SUBJECT: PRESENTATION MATERIALS FROM THE FEBRUARY 22, 1994 MEETING ON
AP600 DESIGN CHANGES

PRESENTATION
TO
UNITED STATES
NUCLEAR REGULATORY COMMISSION

AP600 Design Changes

MONROEVILLE, PA
FEBRUARY 22, 1994

Inadvertent ADS Actuation, Downcomer Pressure

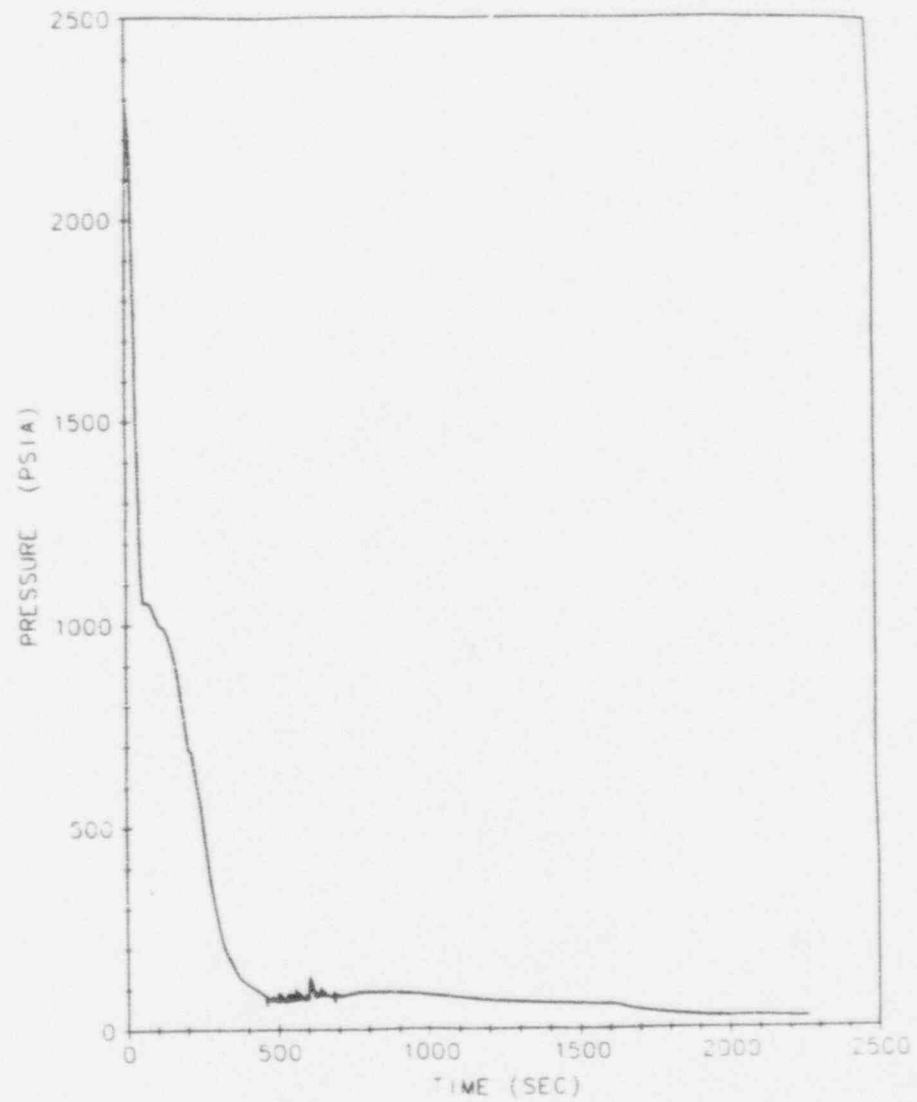
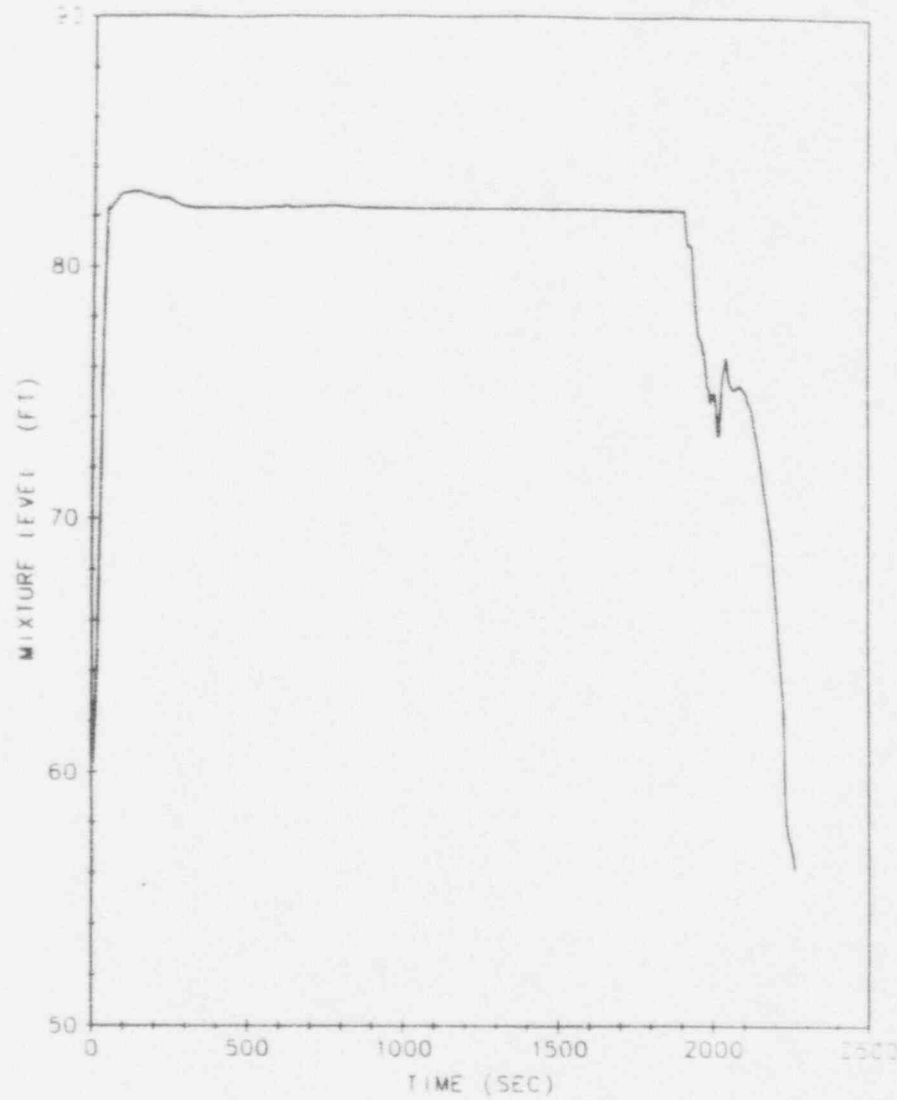
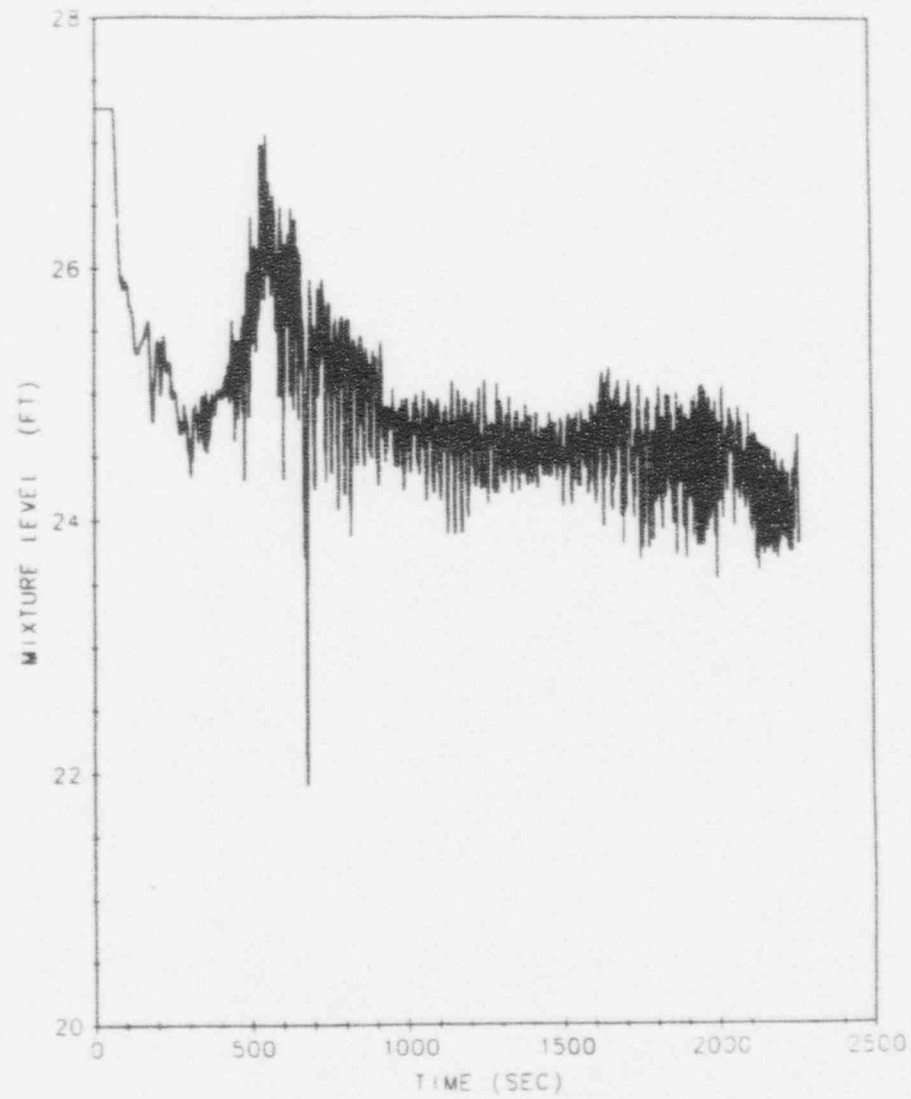
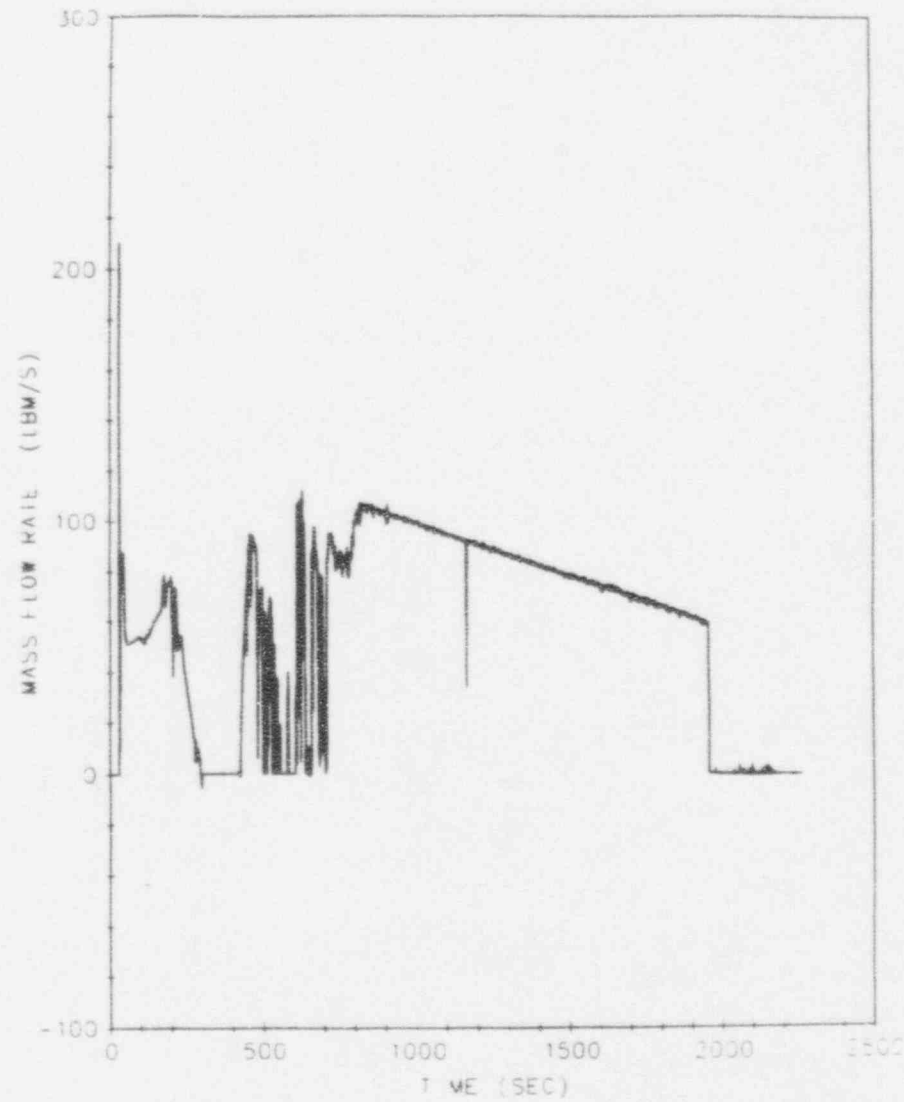
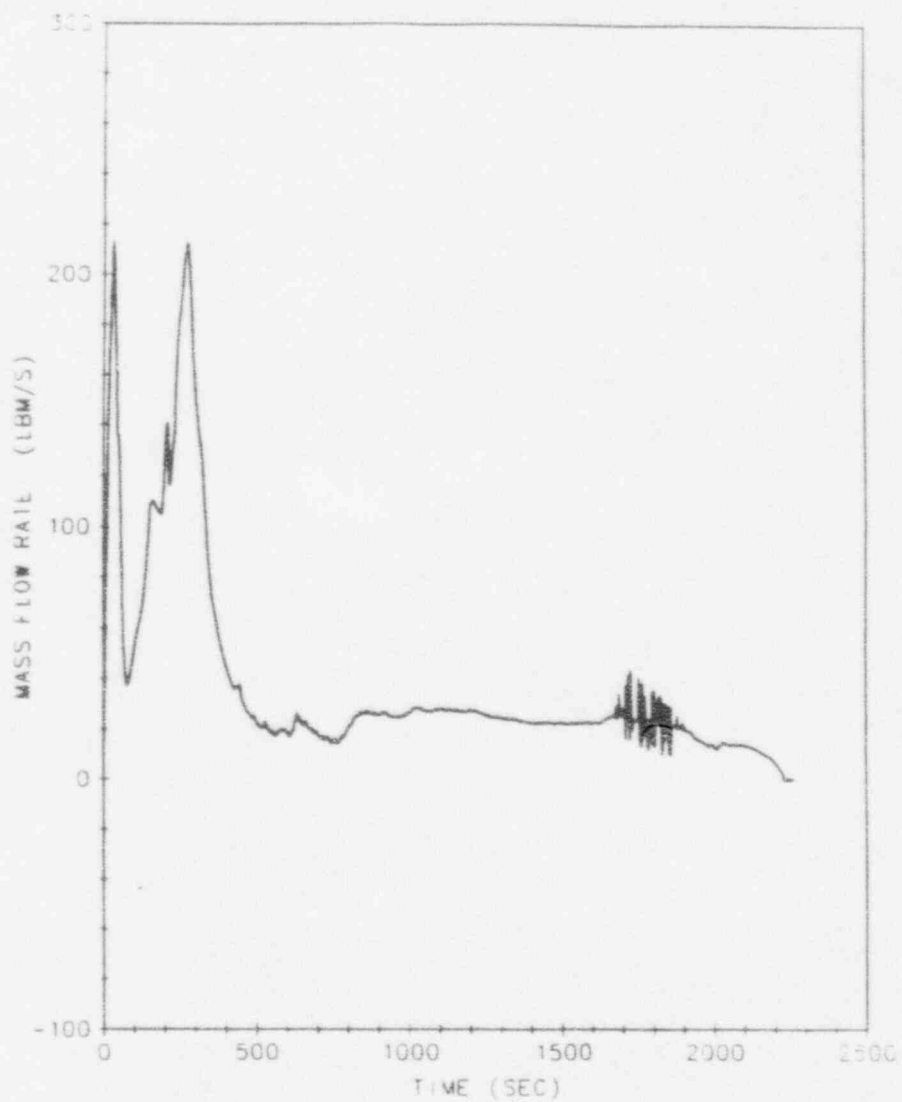
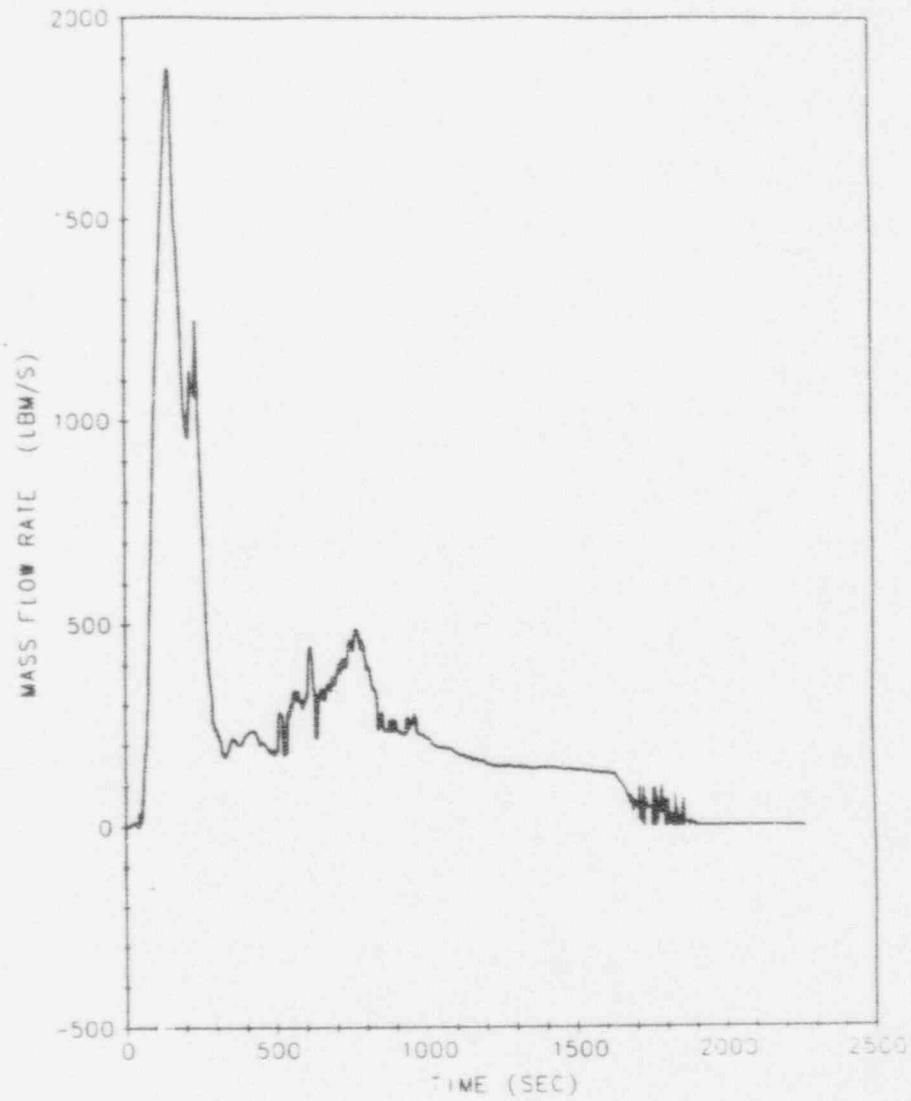
- **Conclusions**
 - **The passive core cooling system design changes:**
 - **Beneficially impact small break LOCA events**
 - **Do not affect large break LOCAs**
 - **The SSAR cases remain bounding for the new design**
